REMARKS

Amendments to the Drawings:

FIG. 2A

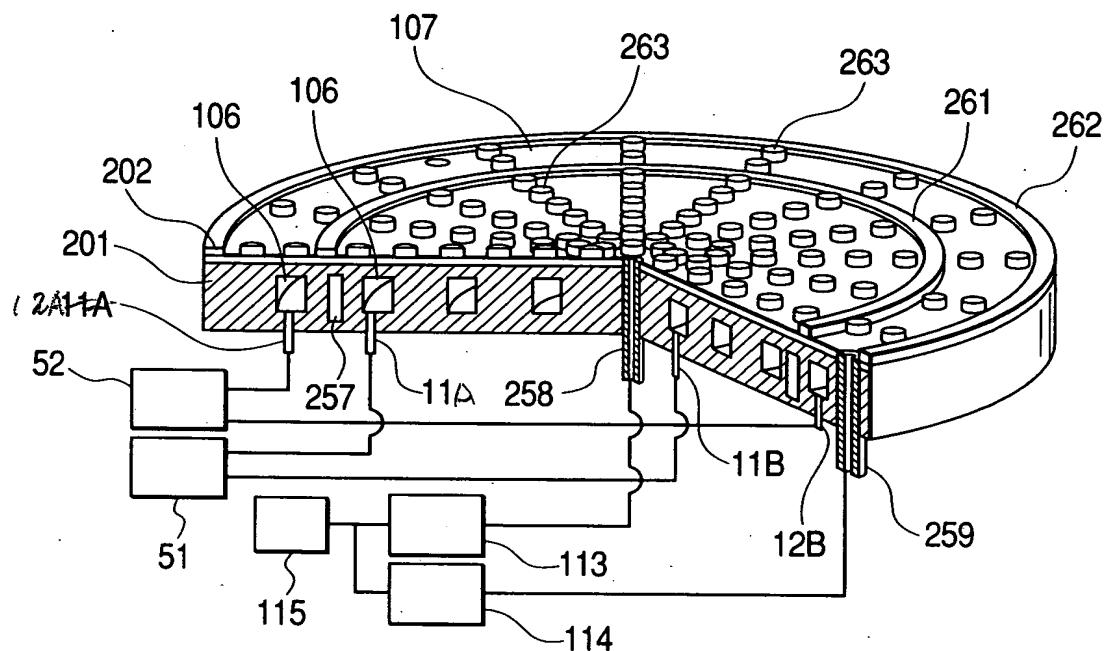
With regard to the objection to the drawings, submitted herewith is a proposed drawing correction of Fig. 2A and 3A and replacement sheets therefor are also submitted noting that reference characters 11A, 11B, 12A and 12B have been properly illustrated. Thus, applicants submit that the drawing objection should now be overcome and acceptance of the drawings is respectfully requested.

The attached sheets of drawings include changes to Figs. 2A and 2B and 3A. These sheets, which include Figs. 2A, 2B and 3A, replaces the original sheets including Figs. 2A, 2B and 3A, in which reference characters 11A, 11B and 12A have been corrected.
